Agenda Item #: 4
SUB-002498-2023

MoCoLink Subdivision

- Subdivision approval to create two (2) legal lots from existing metes-and-bounds parcels.

DETAIL SITE PLAN

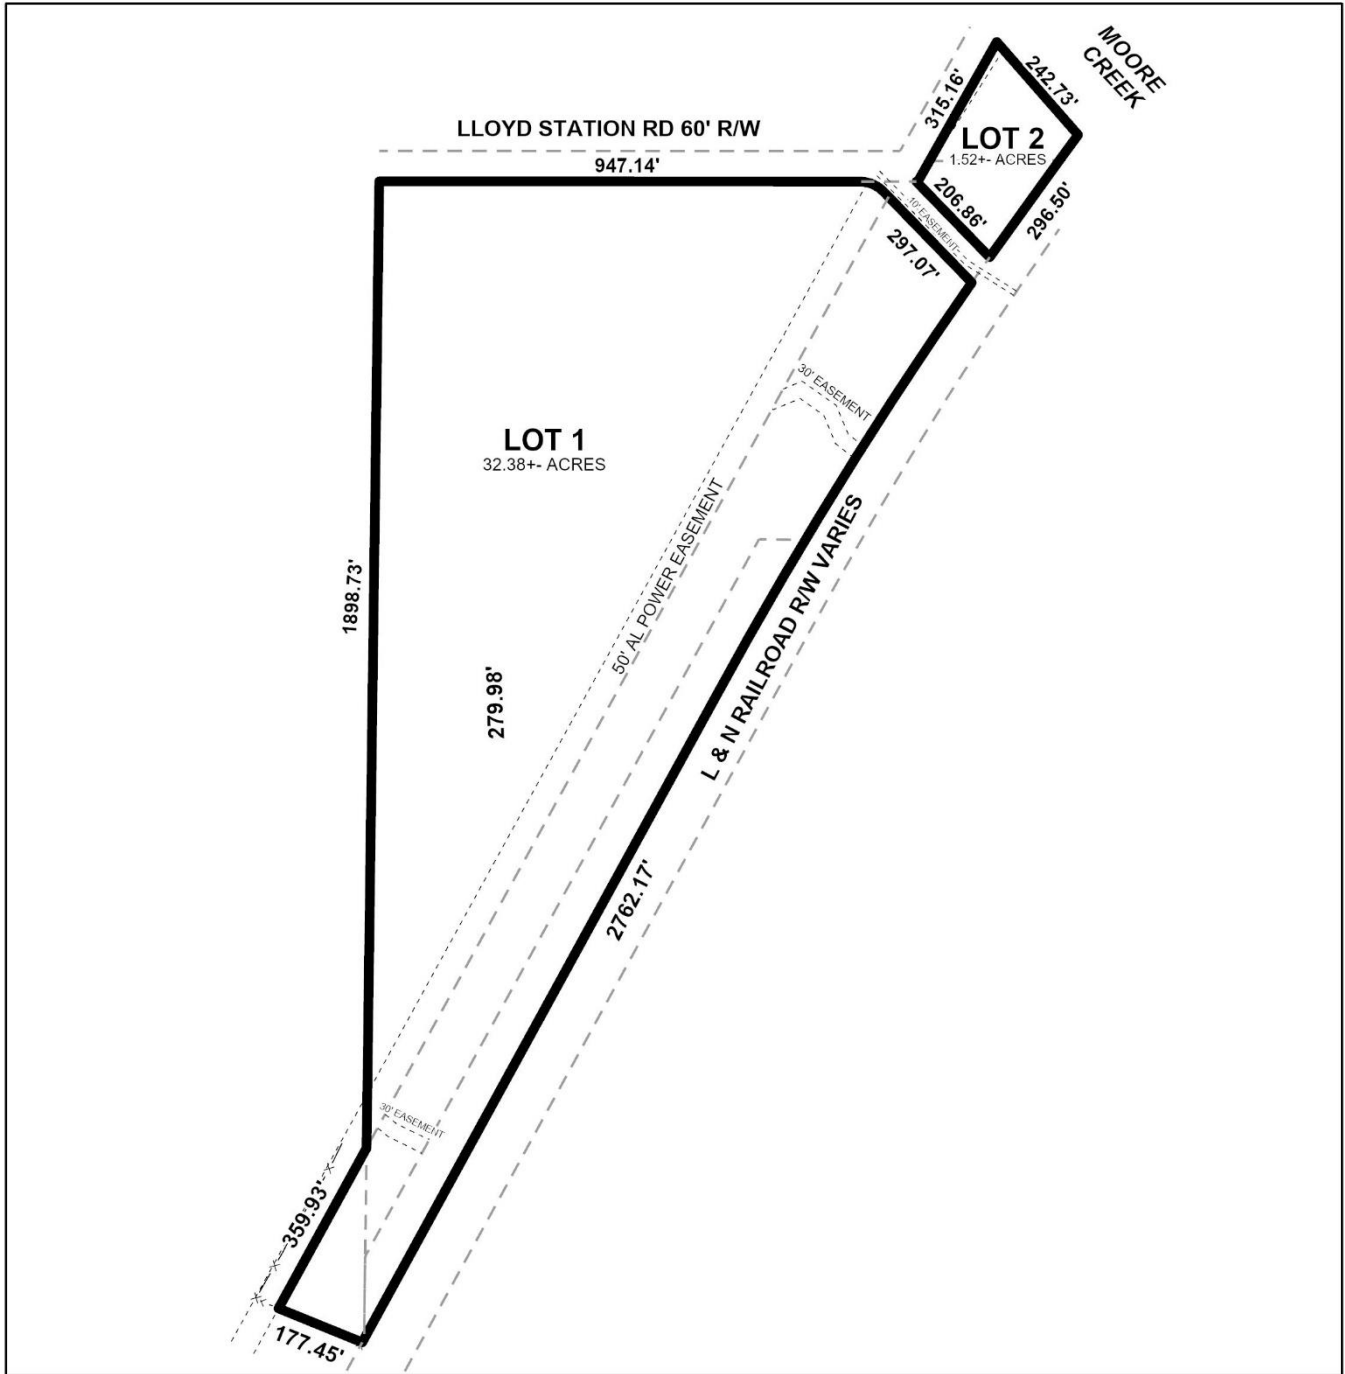
- B. Review and revise the written legal description and/or boundary labels for LOT 1. There is curve and line data that doesn't match. Also, check the west line bearing.

- D. Show and label all flood zones. New maps went into effect on June 5, 2020.
- E. Show and label the MFFE (Minimum Finished Floor Elevation) on each lot that contains an A, AE, or X (shaded) flood zone designation. BFE = 11.

- F. Label the ROW that is dedicated to public ROW for Lipscomb Landing Rd. or provide the recording data for it.
- G. Dedicate the corner radius (25' minimum or as approved by the City Engineer and Traffic Engineer) at the southwest corner of LOT 2 to the City of Mobile, and list the amount of dedicated acreage.

- H. Label the two (2) proposed Drainage Easements shown on LOT 1 as "PRIVATE" or provide the recording data for each easement.
- I. Add a note to the SUBDIVISION PLAT stating that as shown on the 1984 aerial photo (FLIGHT 24 - #86) LOTS 1 and 2 will receive historical credit of existing (1984) impervious area towards stormwater detention requirement per Mobile City Code, Chapter 17, Storm Water Management and Flood Control) as follows: LOT 1 – NONE AND lot 2 – NONE.

- K. Revise NOTE #13. It is listed as "13)" and "14)".
- L. Email a pdf copy of the FINAL SUBDIVISION PLAT and LETTER OF DECISION to the Permitting Engineering Dept. for review at land.disturbance@cityofmobile.org prior to obtaining any signatures. No signatures are required on the drawing.

The subject site has frontage on Lloyds Station Road and Lipscombs Landing, both minor streets without curb and gutter. Lipscombs Landing is not identified on the preliminary plat, nor is a current right-of-way width provided. Therefore, the plat should be revised to label Lipscombs Landing by name, and provide the current right-of-way width on the Final Plat, if approved. Lipscombs Landing has an unspecified right-of-way; therefore, it appears to have a compliant width. Lloyd Station Road has a compliant 60-foot right-of-way; therefore, no dedication would be required. As on the preliminary plat, the Final Plat should retain the right-of-way width of Lloyd Station Road. Per Section 6.B.12. of the Subdivision Regulations, dedication of a corner radius should be required at the Southwest corner of Lot 2 (25' minimum or as approved by the City Engineer and Traffic Engineer).

The preliminary plat does not illustrate the 25-foot minimum building setback line along the street frontages. Therefore, the plat should be revised to illustrate the 25-foot minimum building setback line along all street frontages, if approved.

The site contains several drainage, utility and access easements within. Note #9 on the preliminary plat should be revised to state that no structure may be constructed or placed within any easement without the permission of the easement holder, if approved.

1. Revision of the plat to label Lipscombs Landing on the Final Plat;
2. Revision of the plat to provide the current right-of-way width of Lipscombs Landing on the Final Plat;

3. Retention of the right-of-way width of Lloyds Station Road on the Final Plat;
4. Dedication of a corner radius at the Southwest corner of Lot 2 (25' minimum or as approved by the City Engineer and Traffic Engineer);

5. Revision of the plat to illustrate a 25-foot minimum building setback line along all street frontages, as measured from any required frontage dedication;

7. Placement of a note on the Final Plat stating that no structure may be constructed or placed within any easement without the permission of the easement holder;
